8 Noise and Vibration

8.1 Vibration and regenerated noise

Figure 12: The CoRTN method

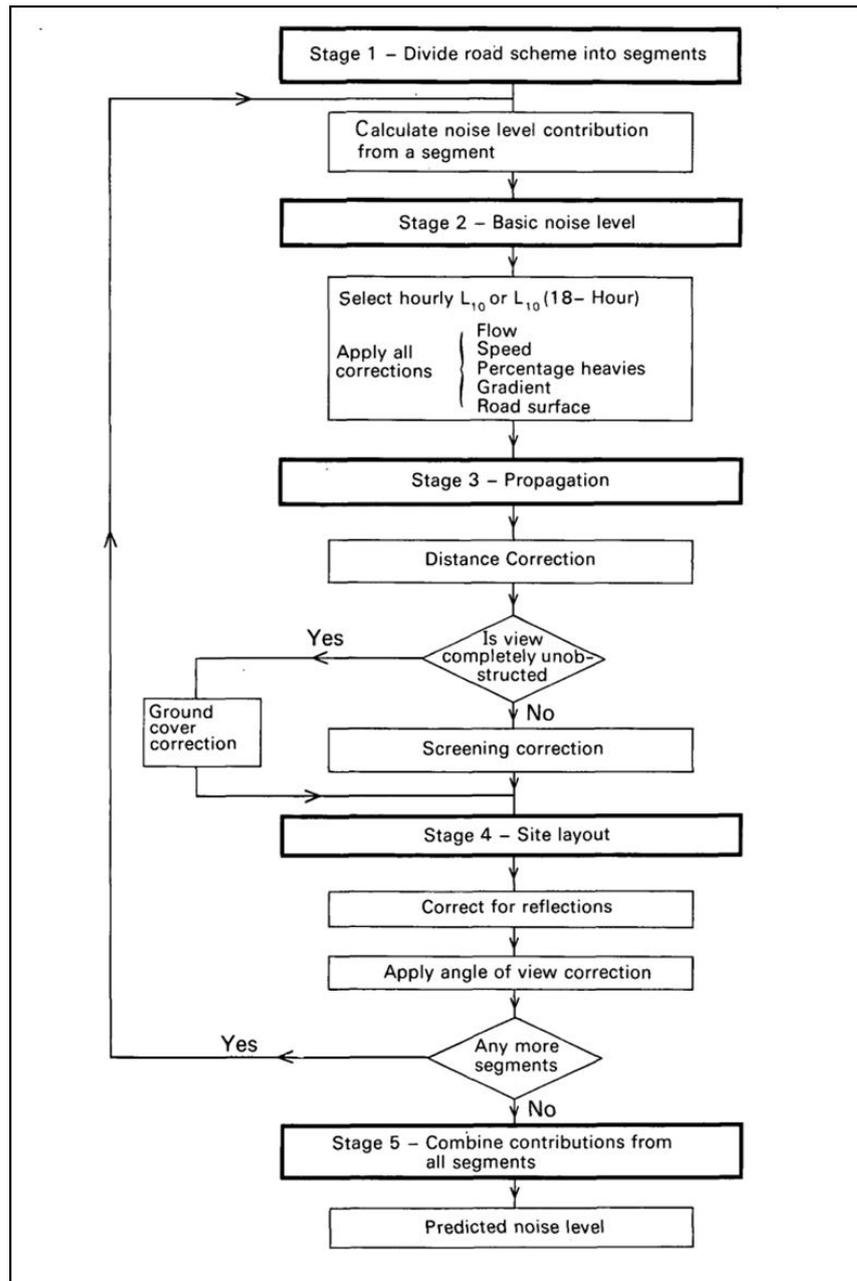
66. *The LMA should provide a flow chart of the noise model that indicates the major elements, including the input requirements, leading to the derivation of noise contours both at ground level and at building façades. This information is to explain the basic steps in determining the characteristics, such as height, extent and acoustic properties, of a sound barrier and how the noise protection provided by that is estimated.*

As outlined in Section 5.1.2 of Appendix J of the CIS, the calculation method was the Calculation of Road Traffic Noise (CoRTN) method, developed in the United Kingdom and specified by VicRoads for traffic noise modelling in Victoria. A copy of the CoRTN document that defines the method is available at http://www.noiseni.co.uk/calculation_of_road_traffic_noise.pdf. Figure 12 included below is from CoRTN and illustrates the method. A brief description of the method is provided following the figure.

The roads are broken down into short segments (Stage 1 in Figure 12). With modern noise modelling, the road is broken into hundreds of segments in order to obtain a high level of detail. For each segment, the calculation is in three steps:

1. Noise emission (Stage 2 in Figure 12). This is how much noise is being generated by traffic on that road segment.
2. Noise propagation (Stage 3 in Figure 12). This is the effect of distance, ground surface and intervening objects such as barriers.
3. Site layout effects (Stage 4 in Figure 12). This is the effect of the receiver site, including the effect of reflections from the facade of the building (generally a house or apartment building).

The noise level at each receiver location is then the combined total of the noise level from all the segments (Stage 5 in Figure 12). To generate noise contours, the noise level is predicted at a grid of receiver locations either on the ground (for the noise contour plots) or on the facades of the buildings (for the facade noise maps).

Figure 14 Risk Management Process

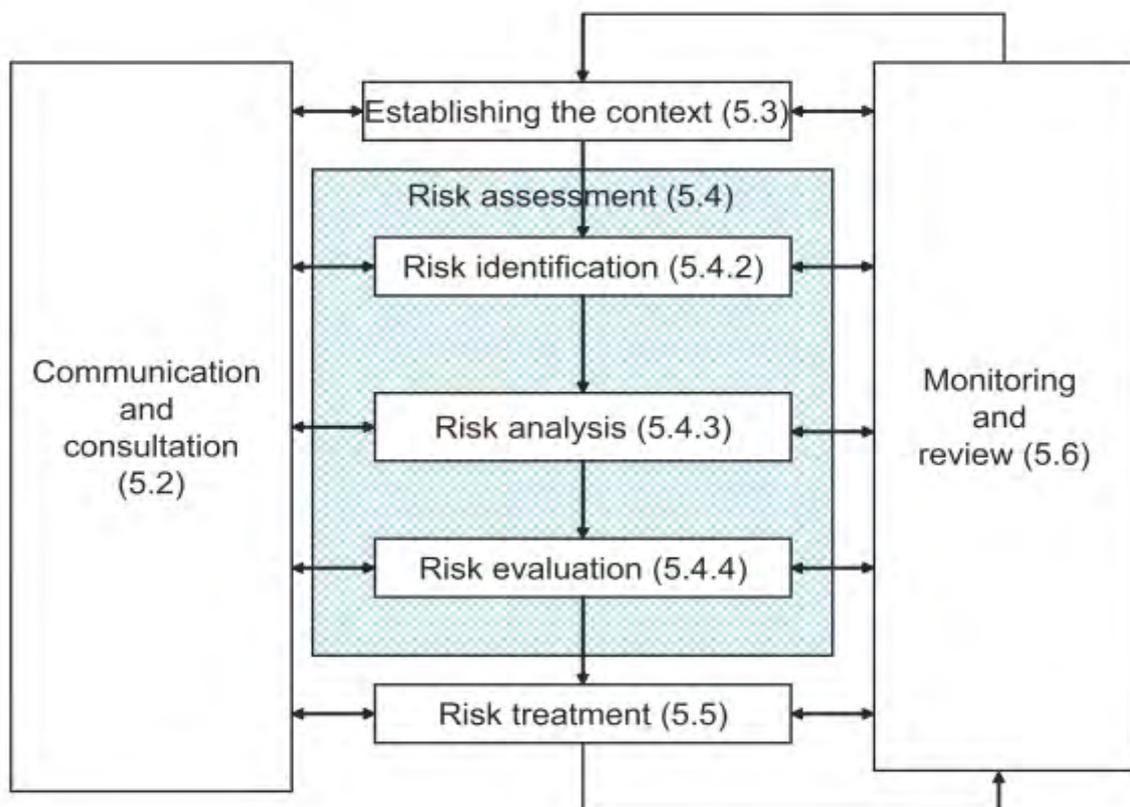
86. *The LMA should provide an overview of the risk assessment methodology and how it accords with relevant Australian Standards.*

The risk assessment process used by LMA for the Comprehensive Impact Assessments, followed *AS/NZS ISO 31000:2009 Risk Management Principles and Guidelines*. This risk management process has been widely adopted throughout Australia and has also been adopted by the International Standards Organisation (ISO).

The following section explains how the risk assessment process used by LMA followed this framework (as shown in Figure 14)⁴².

1) Communication and Consultation – The risk assessment process involved members of the CIS team, specialists and representatives from government agencies through the risk assessment and through subsequent reviews. This high level of engagement was so that the CIS benefitted from the wealth of diverse experience and gained consensus and buy-in from the relevant stakeholders.

2) Establishing the context – LMA provided a reference project with fly throughs, comprehensive mapping as well as the list of overall objectives of the project, to provide the context and scope for the assessment. The consequence criteria was developed, reviewed and agreed to by specialists and LMA during this phase.
